#### Leinster Operations - Temporary Suspension - proposed administrative amendments to conditions of Licence L4612/1989/11

Our ref: PS218743-WSP-PER-MNG-LTR-0003 Rev0 Inspection frequency 15 November 2024

Review of changes in inspection frequency on 15r failure modes - Leinster TSFs

## **Appendix 1 – Monitoring Bore locations**

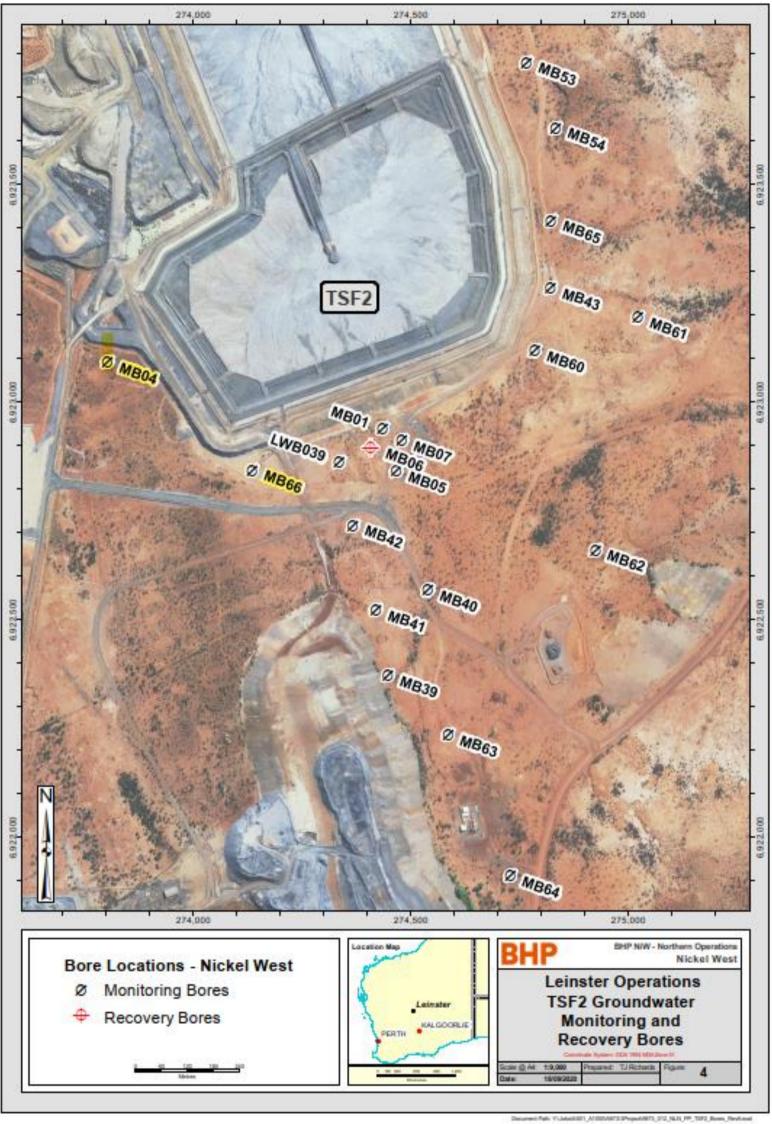
s been consistently dry since the bore was drilled in I is no longer considered an appropriate or safe ater monitoring location – located within a declared clusion zone.

was drilled to a depth of 39 m into weathered schist nstone units. Minor water was reported at a depth of tween 2001-2002.

sits on the eastern side of the Perseverance Fault, e drawdown footprint of the Perseverance Mine. vels are not expected to recover in this bore due to g underground dewatering and the long-term of deposition to TSF Cell 2 (decommissioned).

vels are collected from nearby bore MB66. This bore I on the western side of Perseverance Fault and is
